Date: September 7, 2023  
To: TRPA Hearings Officer  
From: TRPA Staff  
Subject: Single-Family Residential Rebuild for North Shore TVCA LLC,  
6650 North Lake Boulevard, Tahoe Vista, Placer County, CA; Assessor's Parcel  
Number (APN): 117-072-006; TRPA File No.: ERSP2023-0707

**Requested Action:**

**C2.2**

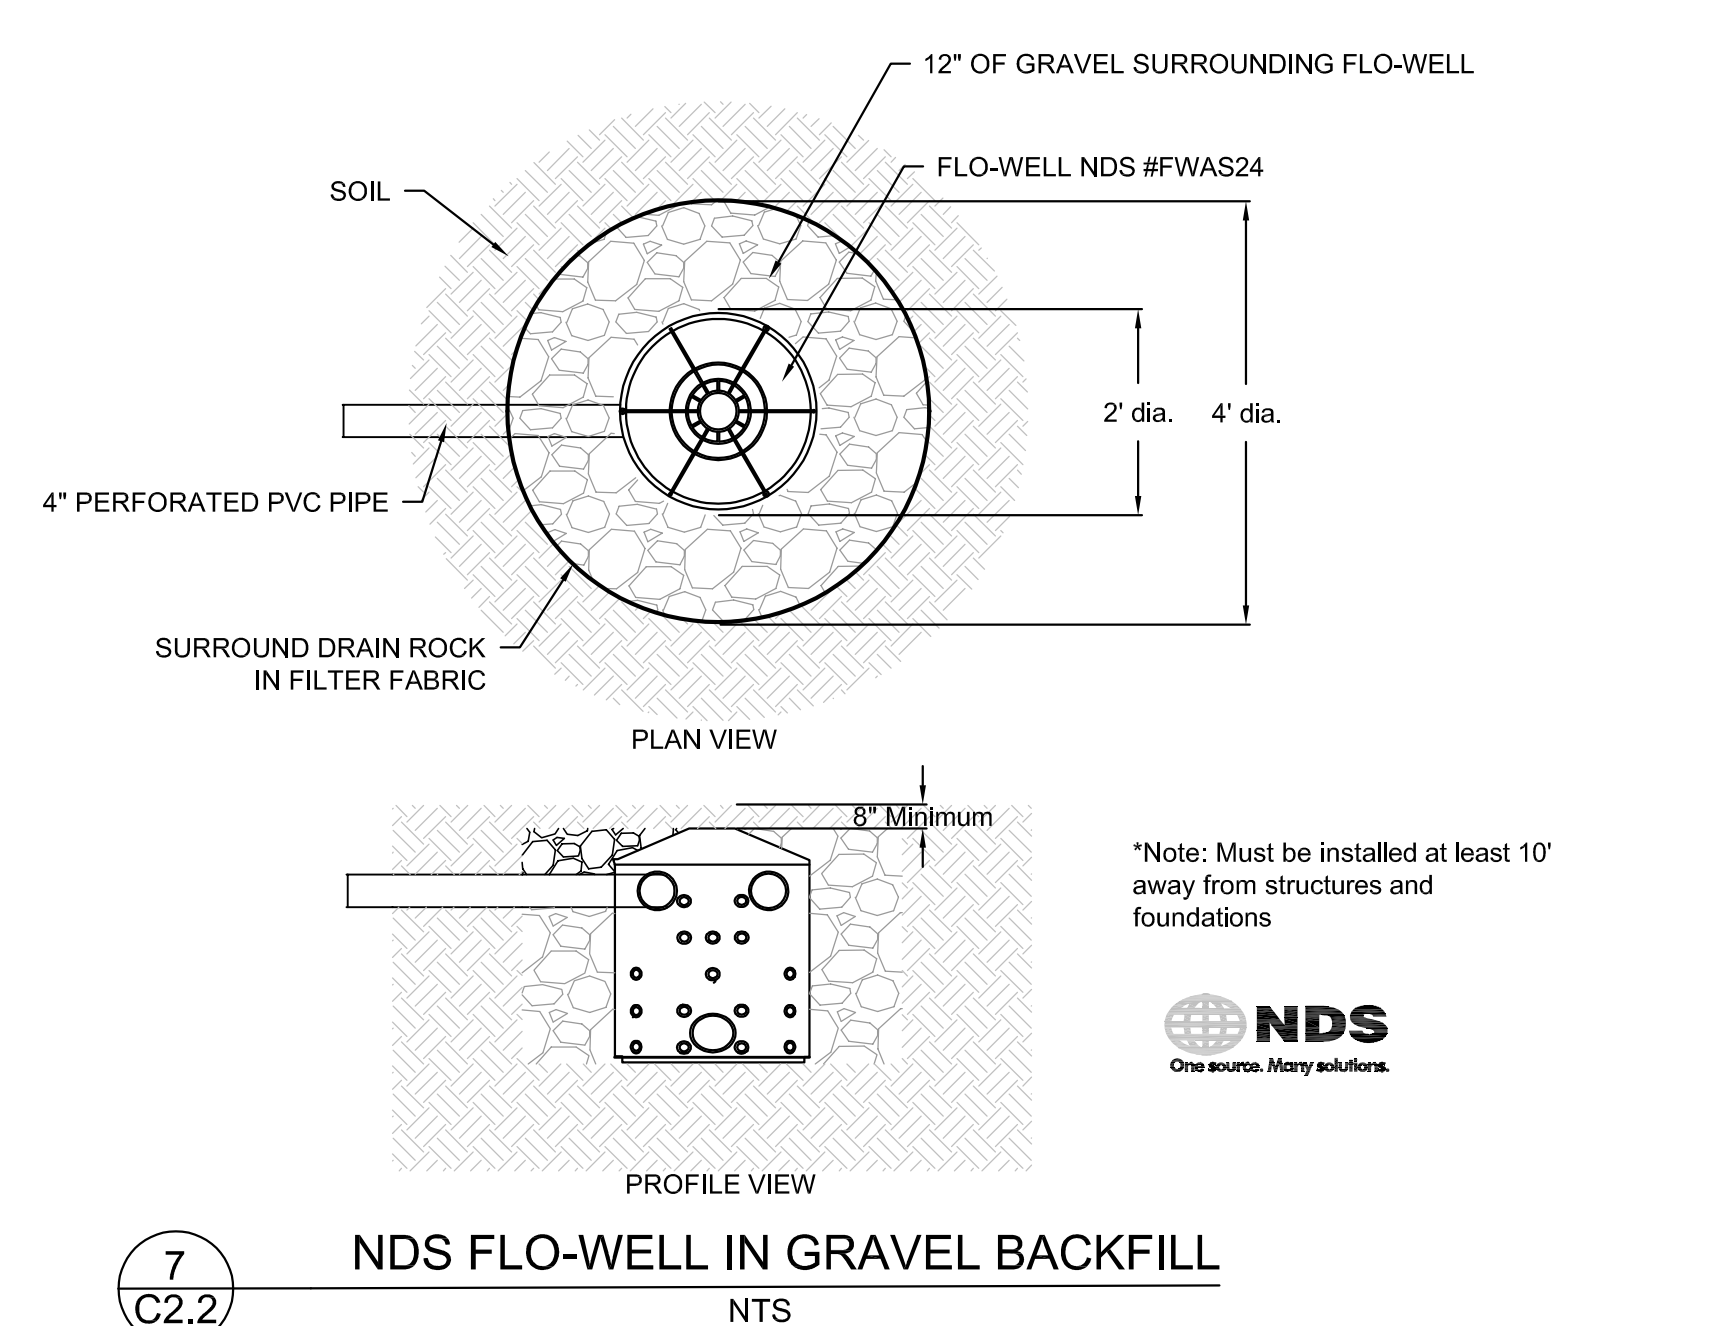
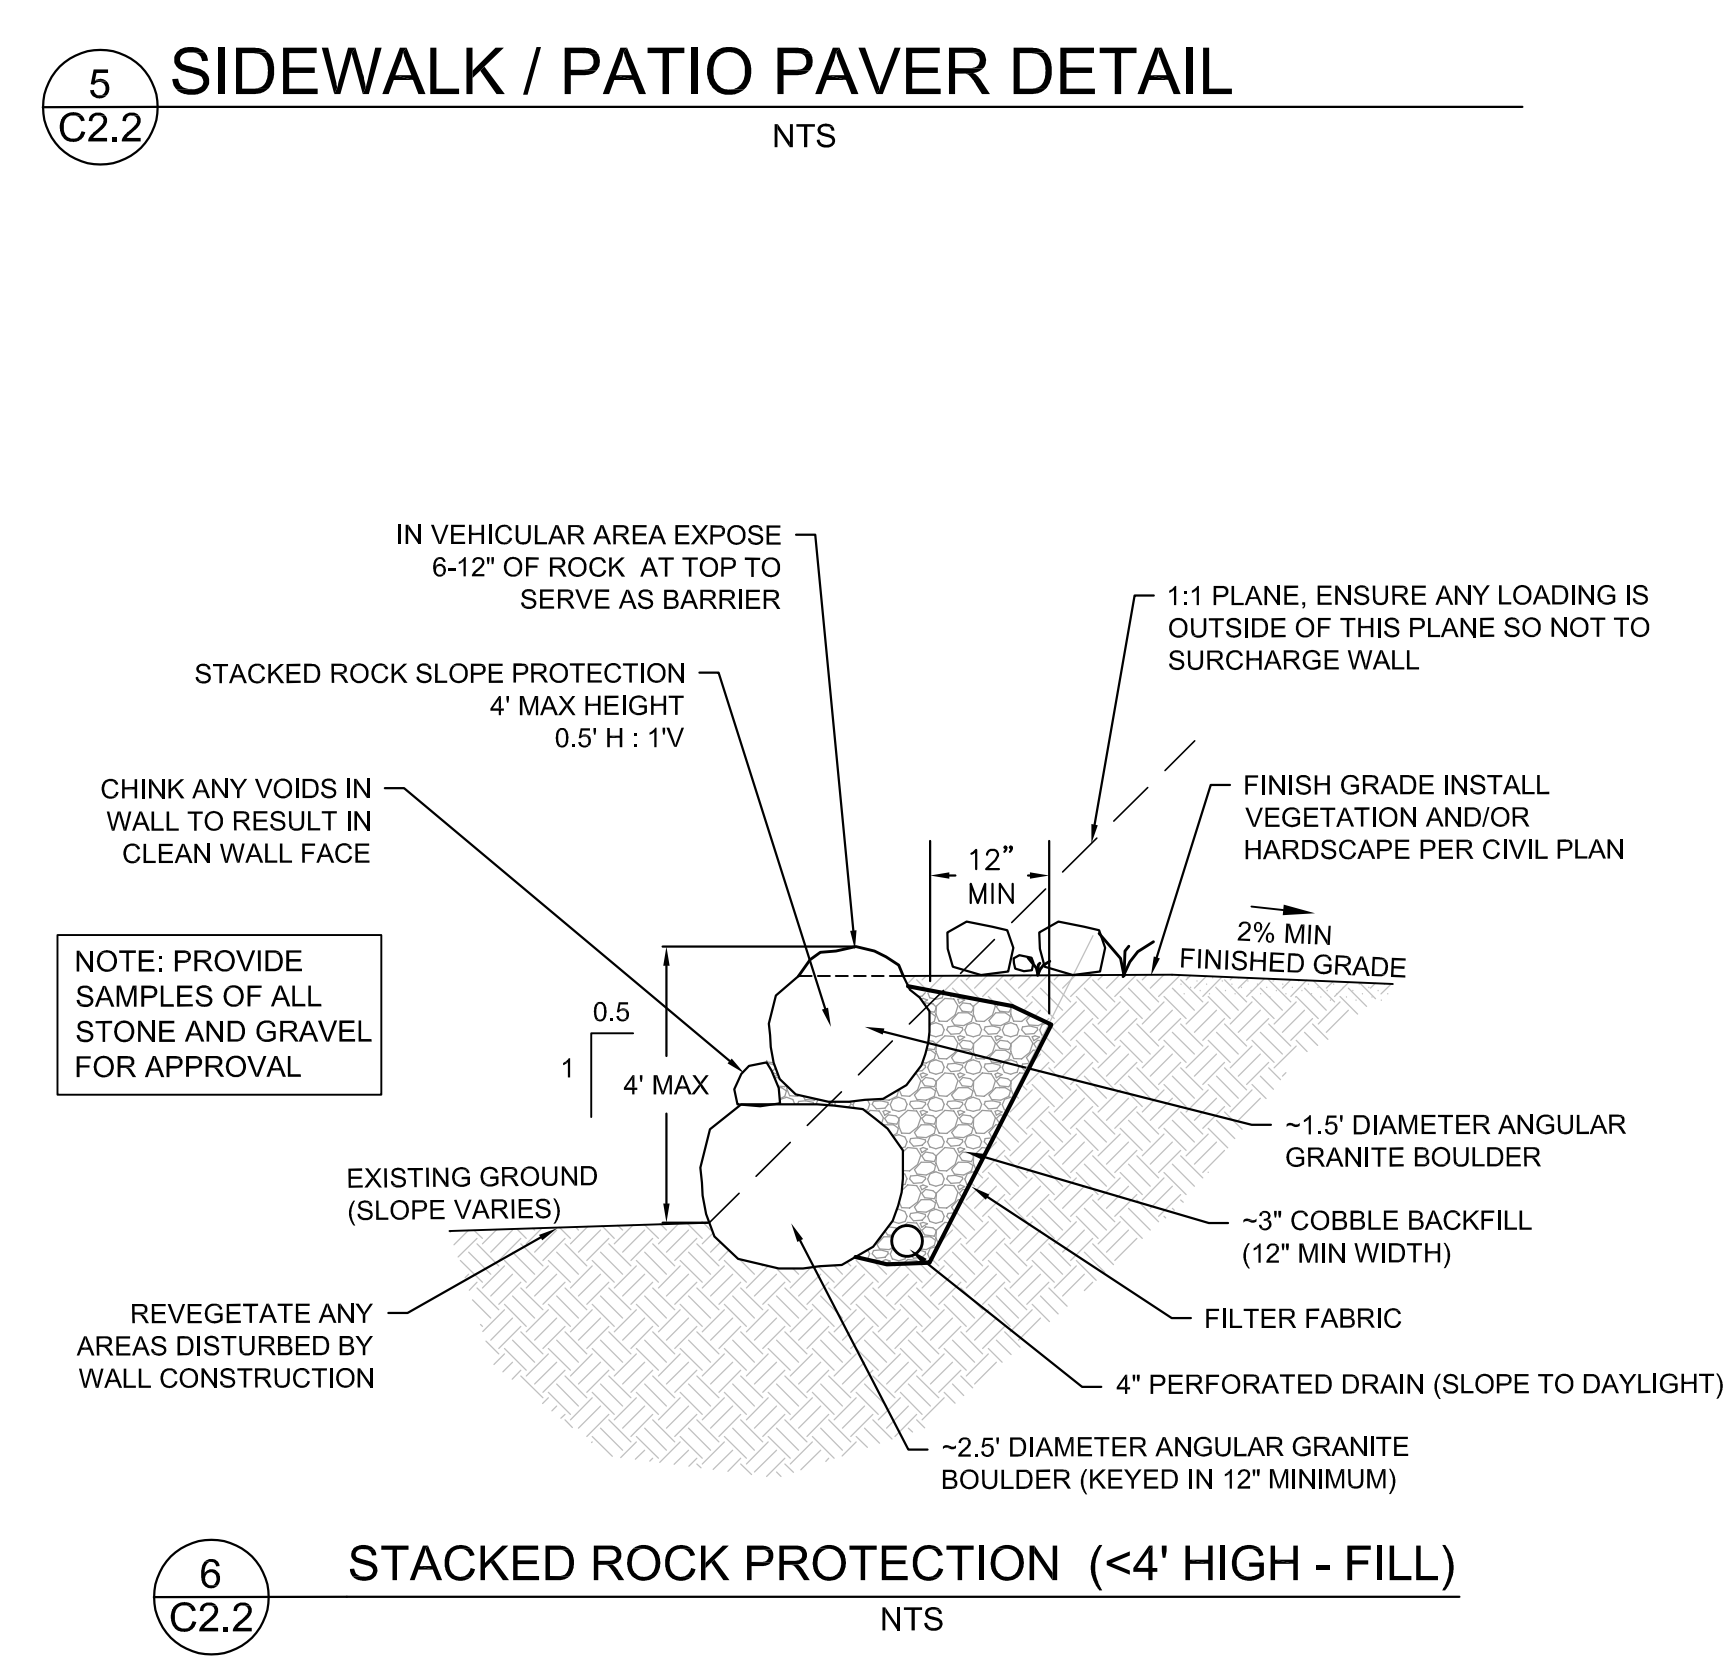
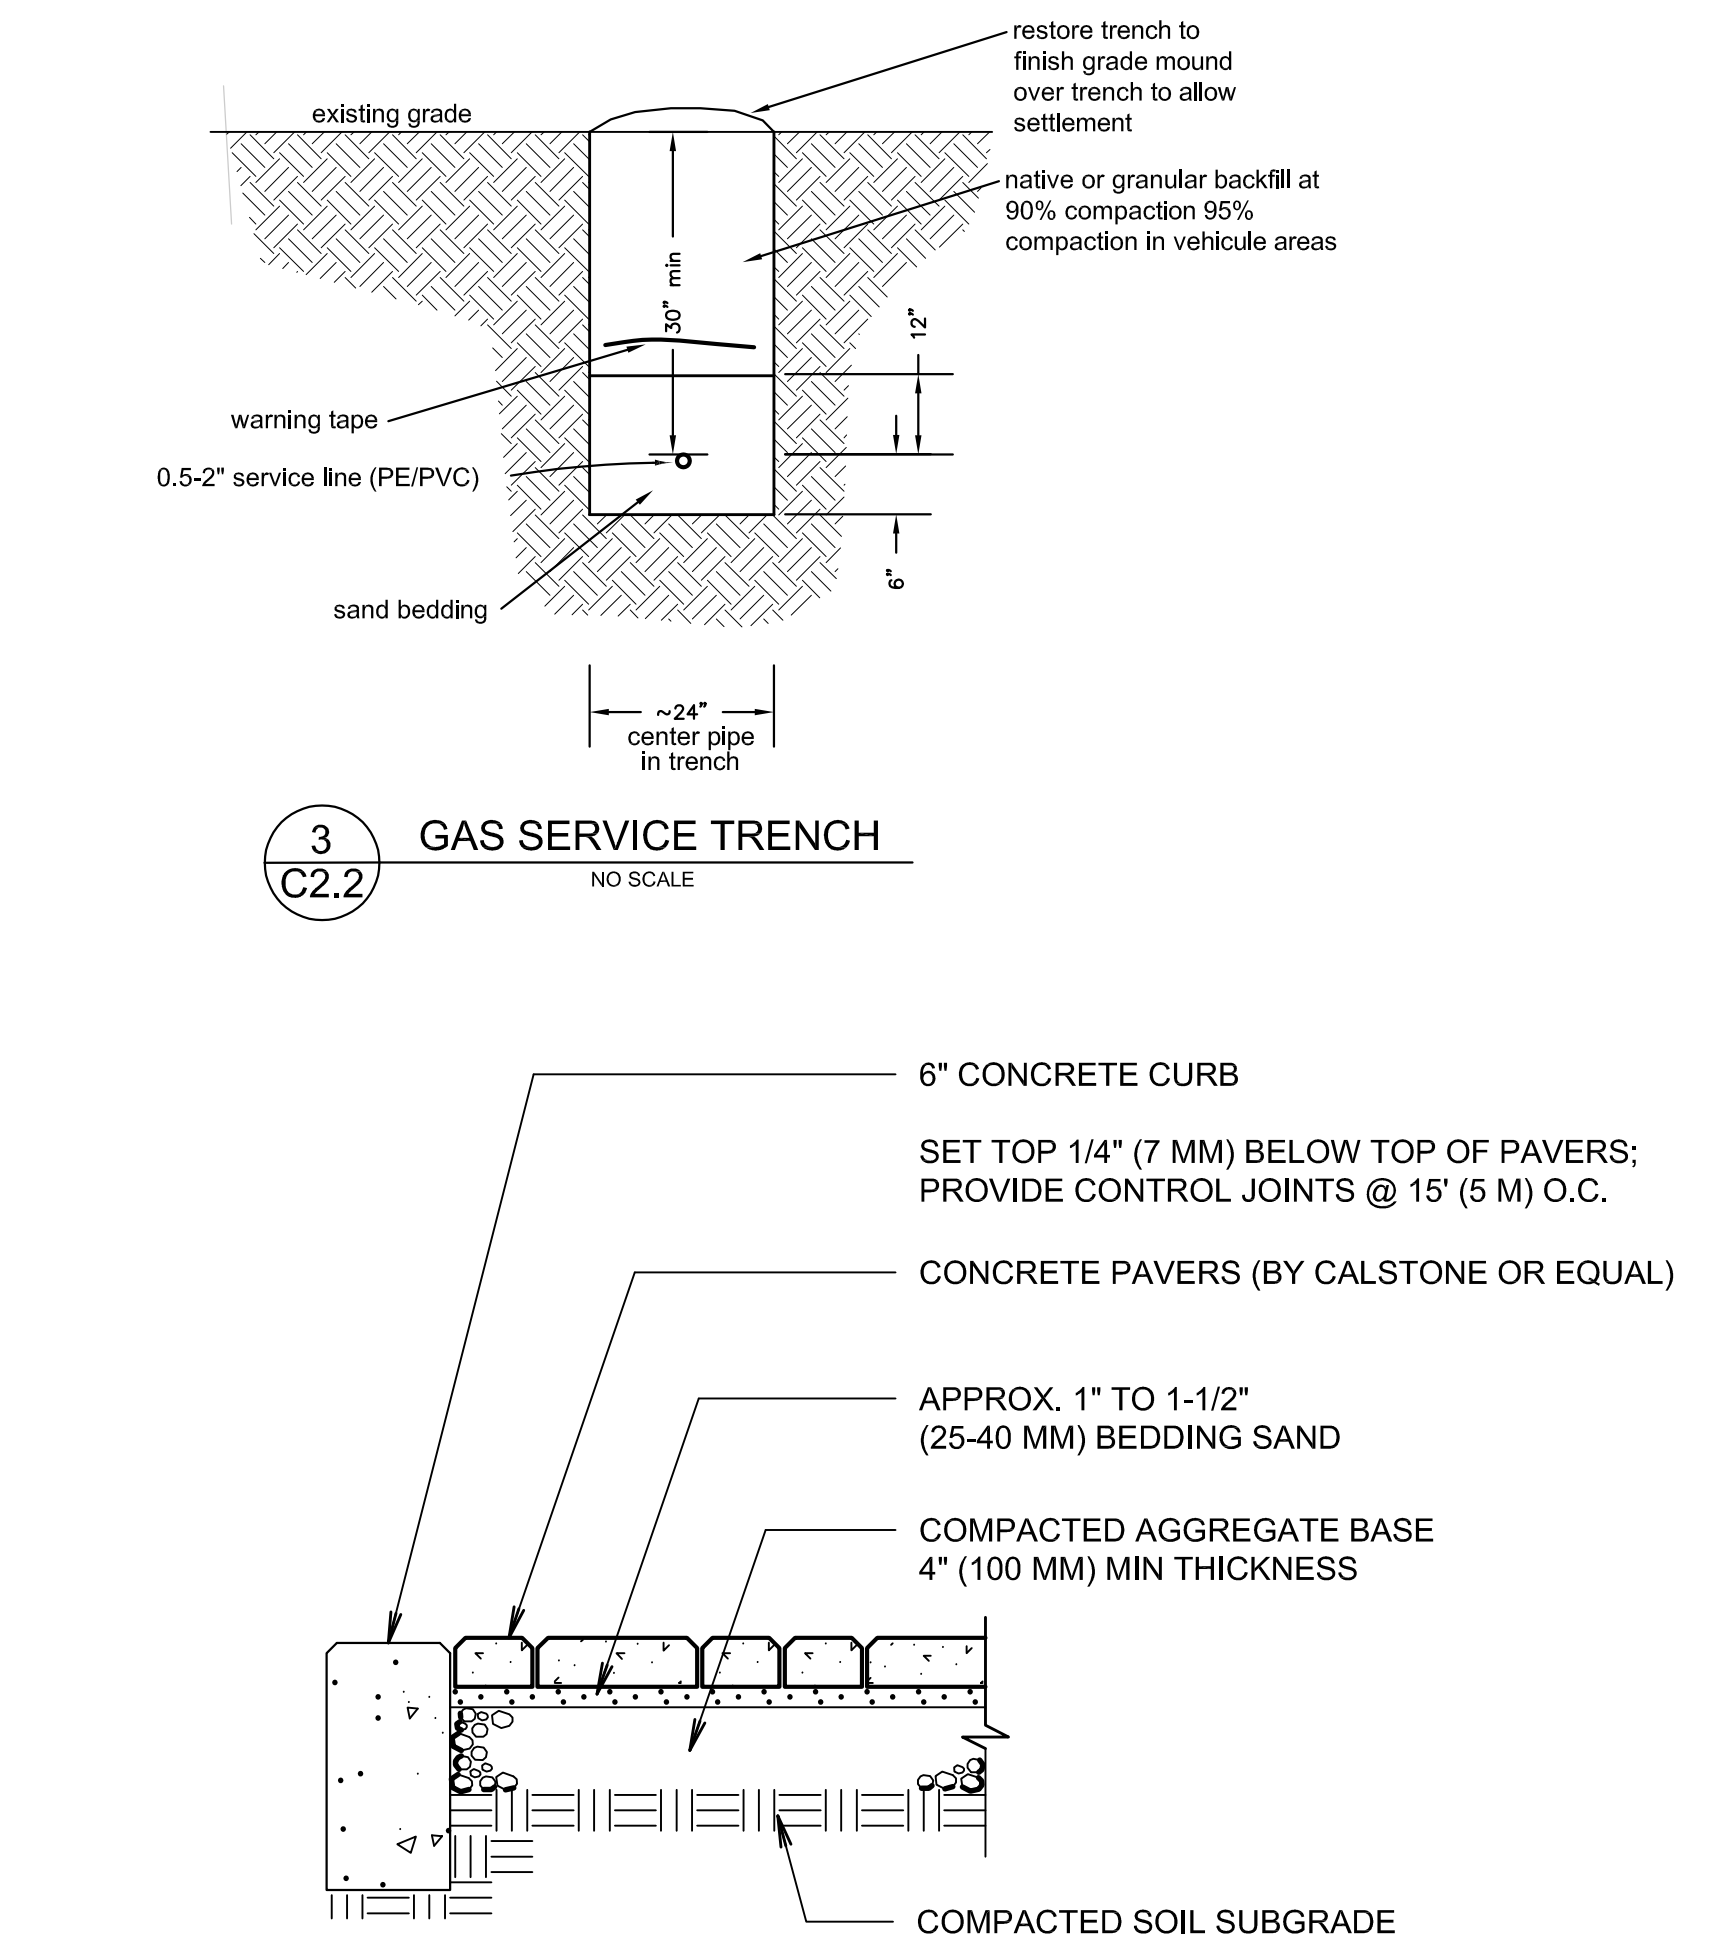
- (10) Enhance driveway BMPs with 3 cleanable sediment traps (detail 2/C2.2) located at 2 points along treatment P and where treatments P and M meet. Provide driveway edge armor (3 inch deep by 12 inch wide infiltration trench or suitable alternative) adjacent to the driveway edges that do not have BMP treatments. Expand armor width to the toe of slopes adjacent to the driveway.
